Dear Valued Customer,

Problem 1: Coil and Box instructions may be activated unexpectedly when there are 3 or more branches.

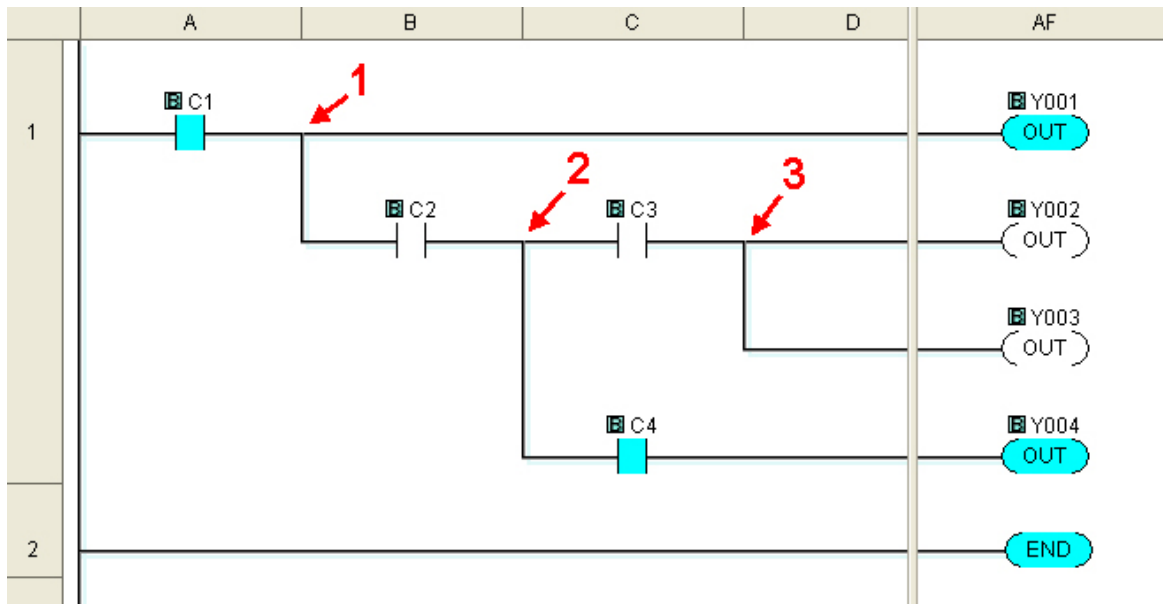
Please refer to the following example program. There are 3 branches indicated with the numbers 1, 2 and 3. Even if the contact with C2 is off, the Output instruction with Y004 is activated.

These problems are related to the ladder program compiler in the CLICK Programming software. When there are several branches in a rung, the CLICK Programming software compiles the rung incorrectly. As a temporary solution, we recommend that each rung should activate only one Coil or Box instruction, or a group of Coil and/or Box instructions. Here is an example. This is a modified version of the example program for Problem 1.

Problem 2: Coil and Box instructions may be activated unexpectedly when there is a vertical line.

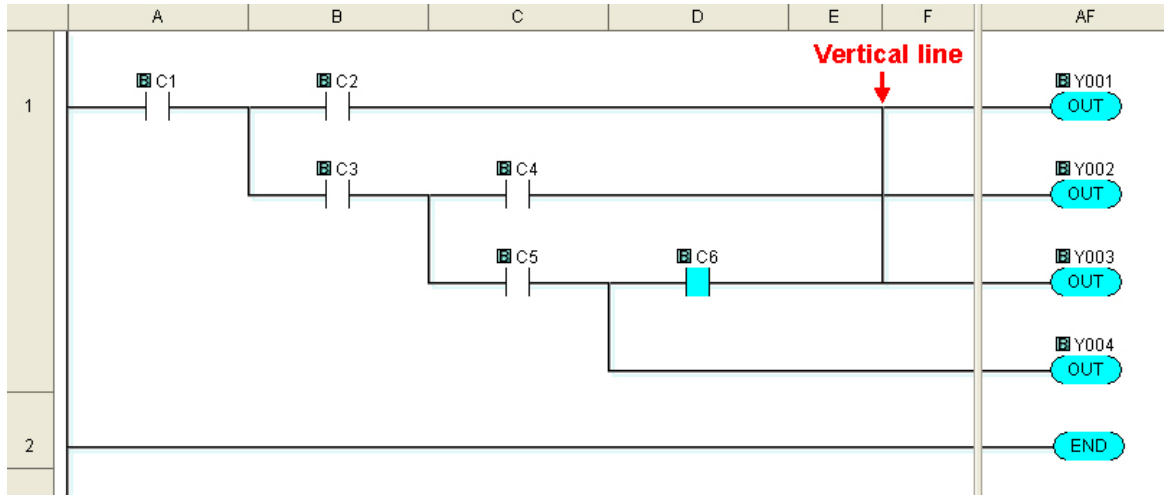
Please refer to the following example program. There is a vertical line between the column E and F. When the contact with C6 is off, all Output instructions with Y001 to Y004 are activated.

Problem 3: Coil and Box instructions may not work correctly when the For instruction is used in a rung with branches.

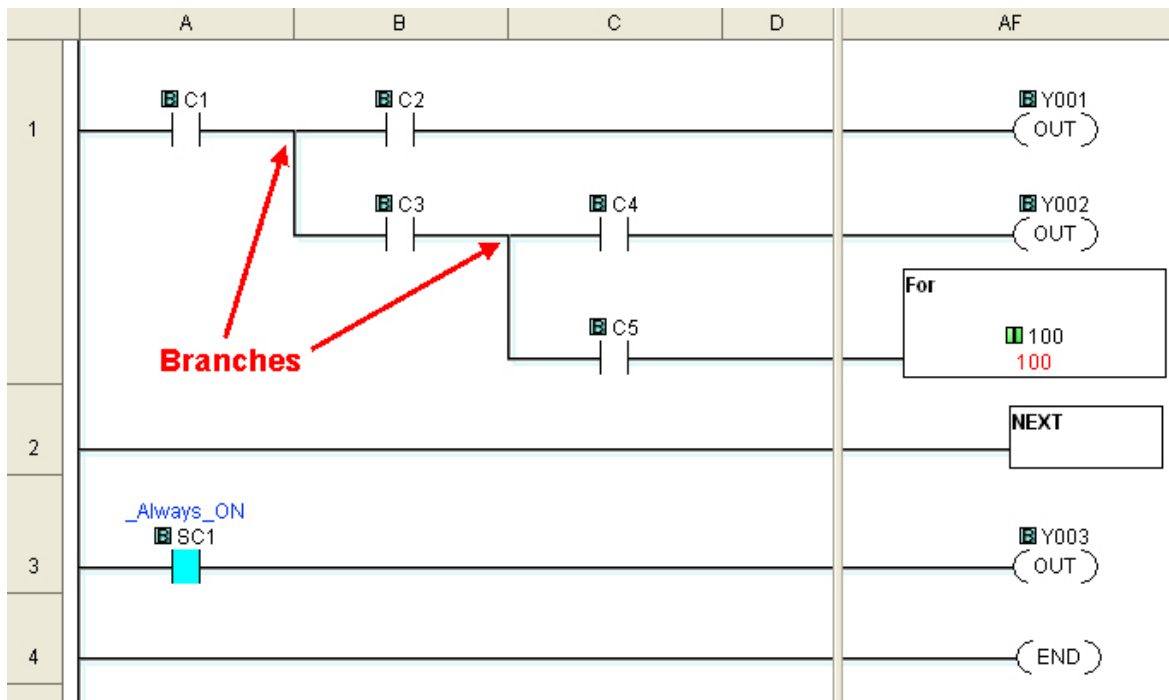
Please refer to the following example program. The first rung has 2 branches and a For instruction. The For-Next loop finishes at Rung #2. However, the Output instruction Y003 on Rung #3 is not activated even though the rung status is true.
